### **Grid Planning Assumptions**

1. Thank you for the opportunity to submit on the "Grid Planning Assumptions (GPA) February 2008 draft". No part of Mighty River Power's submission is confidential, and we are happy for it to be publicly released.

## Initial Statement of Opportunities

**Figure 25: Flow into Christchurch from the south**

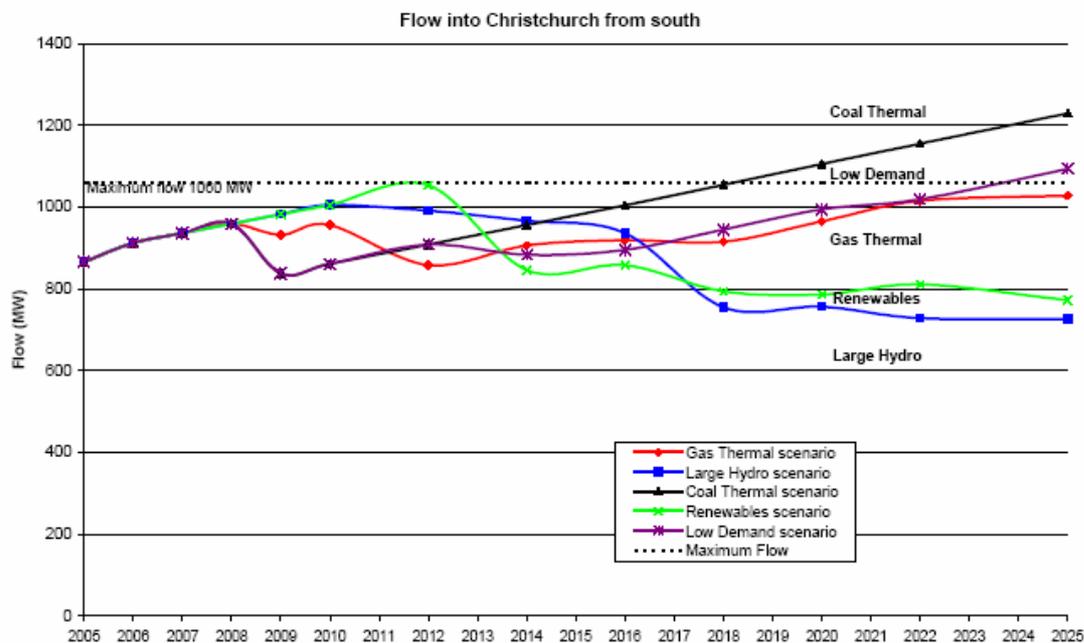
An example of how this confusion manifests itself can be seen in Appendix 7 of the Draft Initial SOO where transmission flows into Christchurch are analysed for each of the Commission’s five scenarios (see following diagram).

If we were to take these scenarios at face value, we would assume that:

- (i) Except in the case of the renewables scenario, no additional transmission is required until 2018
- (ii) Even under the renewables scenario, power flows just touch the 1060MW limit in 2012, and then fall away on an ongoing basis out to 2025 (and probably beyond).

Understandably, we were somewhat disconcerted when, in reviewing the assumptions for the renewables scenario, we saw that they included a 50MW wind farm in Christchurch by the year 2009 and a 210MW hydro station on the West Coast (Dobson) by 2013. Nothing addressed the very plausible chain of events, even under a renewables model, in which only one, or possibly neither, of these projects got underway, let alone within these timeframes. Given that demand both in Christchurch and north of that region is growing at approximately 20MW/year, these two *potential* developments have an enormous effect on the point in time at which transmission investment is needed. The SOO even highlights the critical nature of this

We find it especially worrying that the Commission did not note this warning in the SOO itself. It is possible that, without the postulated investment, the limit into Christchurch could be breached in 2013 (given the analysis uses 2-yearly steps). Hence transmission investment could be needed less than 8 years from now: a fact which is buried by this scenario (hence the need for a baseline).

However, it is only prudent that the Commission makes it clear in the SOO what will happen if no generation investment occurs, particularly where constraints are critically dependent on local generation levels. Parties are unable able to discern what the alternatives might be if this type of baseline information is not provided, as they cannot see where or when the initial decision/s to either build new transmission or invest in alternatives are taken (i.e. you never get to see when the first deferment is needed or possible unless you can see where it will be required based on current and committed asset capability). Nor can parties readily discover what the reason for the increased levels of generation are under these scenarios (i.e. is it motivated by a desire to alleviate a constraint, or simply because of access to fuel sources such as wind or water).
